Professor Francis T.K. Au
Professor and Head, Department of Civil Engineering
The University of Hong Kong

Opinion

1. Appropriateness of Holistic Proposal for Ascertaining the As-Built Condition

Figure 6.4.3.3.1 A typical slab-wall joint (from Detail 1 of [J6/4071])

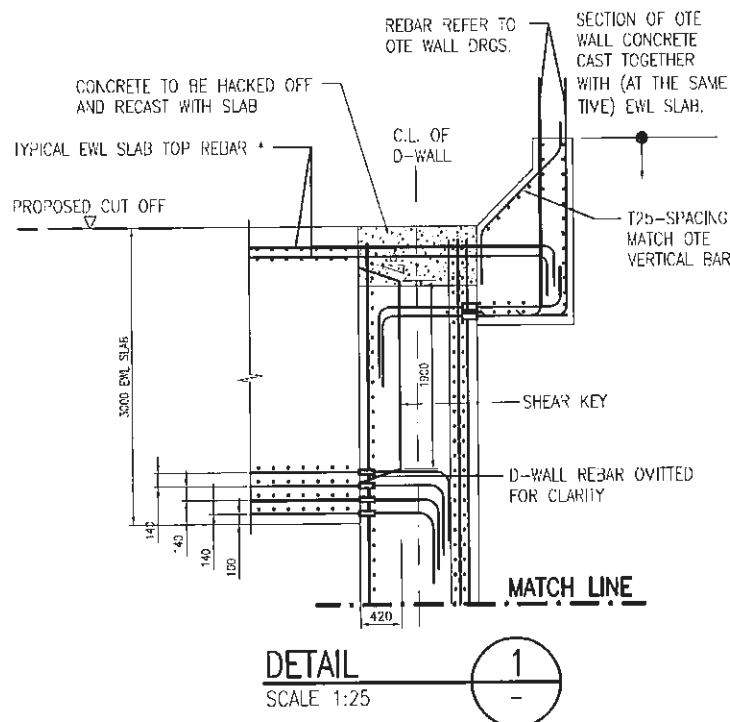
- 6.4.3.3 Recently, Atkins has submitted design calculations about the performance of the revised slab-wall joint details (Atkins's Report) [J6/4557-J6/4562]. In Atkins's Report, only some calculations for a typical slab-wall joint are provided, it is certainly not enough. Calculations must be carried out on all design variations of slab-wall joint to ensure their safety. There are a lot of problems in the calculations in Atkins's Report. In view of the large number of variations of slab-wall joint details, a typical detail shown schematically in Figure 6.4.3.3.1 is used for discussion.

- 6.4.3.4 In page 3 of 5 of Atkins's Report [J6/4559], Atkins attempts to calculate the horizontal shear stress at the additional construction joint inside the slab-wall joint. However, these calculations for the horizontal shear stress at the additional construction joint are unacceptable. The equation used (i.e. $v_h = 6 F (D^2/4 - y^2) / (B D^3)$) is for evaluation of shear stresses in a homogeneous beam under shear due to flexure at elastic state. It does NOT give any estimate at all of the horizontal shear stress generated at the additional construction joint inside the slab-wall joint. It gives the shear stress within a beam at the elastic stage only. A reinforced concrete beam is not homogeneous as it comprises both concrete and steel reinforcement, and hence the equation used by Atkins is unsuitable. Equation 6.19 of the Concrete Code [H8/2875] is normally used to estimate the shear stress of beams and slabs at ultimate limit state and the behaviour is assumed to be inelastic.

Figure 6.4.3.5.1 Assumption of additional shear key in slab-wall joint [J6/4559]

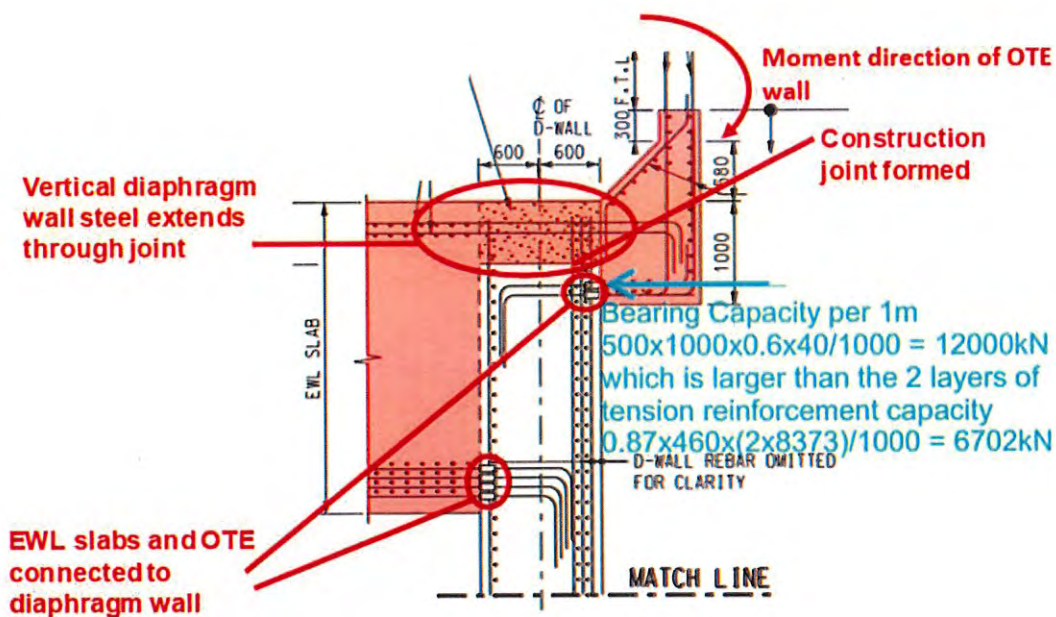
- 6.4.3.5 In the lower half of page 3 of 5 of Atkins's Report [J6/4559], Atkins refers to a cross sectional diagram of the revised joint (which is reproduced in Figure 6.4.3.5.1 below) claiming that the pink down-stand part of OTE wall can act as a shear key to help resist the horizontal shear stress at the additional construction joint. However, no calculation has been provided by Atkins to substantiate this claim. It is noted that the bearing force between the diaphragm wall (shown in white) and the down-stand part of OTE wall (shown in pink) acts at an eccentricity on the new concrete cast at a later date to replace the concrete at the top of the diaphragm wall hacked away (shown in pink), thereby also creating a bending moment. Apparently, the top reinforcement has not been designed to resist the combined tension and bending moment. It is uncertain if the horizontal shear resistance at the additional construction joint and the bearing resistance at the down-stand can indeed act together but not fail progressively. It should be demonstrated by calculations and/or experiments.

Figure 6.4.3.7.1 A typical slab-wall joint

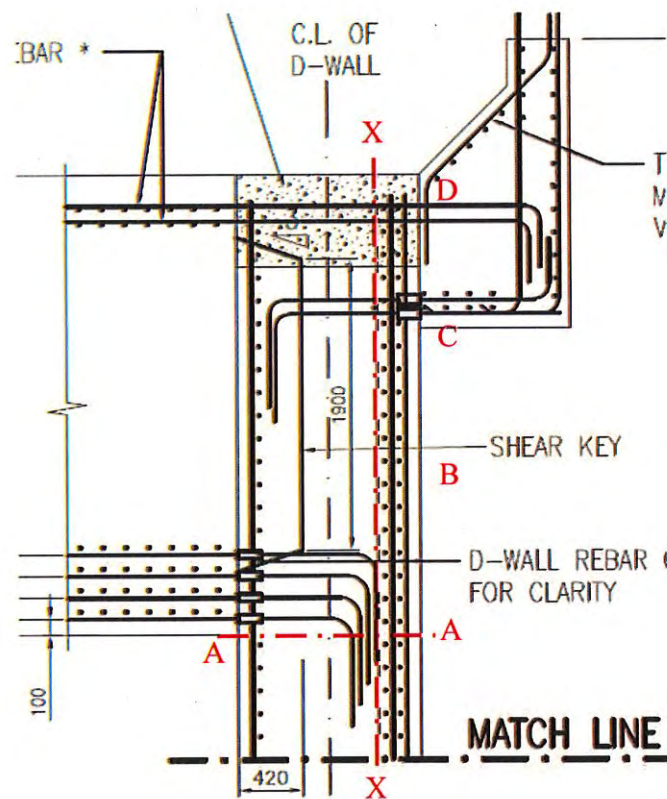
6.4.3.6 Further, in its Report, Atkins has not considered the stresses inside the slab-wall joint using the principles underpinning the design of common beam-column joints as described in Section 6.8 of the Concrete Code [H8/2924-H8/2926] on standard beam-column joints. Considering just the possible cracks outside the joint does not address the issue at all. If the same rationale adopted by Atkins were followed with the analysis of the standard beam-column joints in common buildings, there would not be any need for checking the joint shear stress (Clause 6.8.1.3 of the Concrete Code) and providing horizontal joint shear reinforcement (Clause 6.8.1.5 of the Concrete Code) inside the joint. A simple check of its available strength to satisfy equilibrium can give an initial indication of whether there is any problem.

6.4.3.7 Figure 6.4.3.7.1 below shows the slab-wall joint enlarged for clarity. From the structural analysis, it is possible to identify certain critical bending moment, axial force and shear force at the bottom of slab-wall joint (i.e. Section A-A) at the ultimate limit state. Based on these internal forces, the designed tension taken by the group of reinforcement near the outer face of the diaphragm wall at level A can be determined. The forces taken by these reinforcing bars at level D should be virtually zero. Therefore Section X-X from level A to level D is a critical shear plane as the shear stresses there can be very high and they should be checked numerically. Similar design checks for various critical sections within the joint should be performed for each and every type of cross-sectional details adopted along the east diaphragm wall.
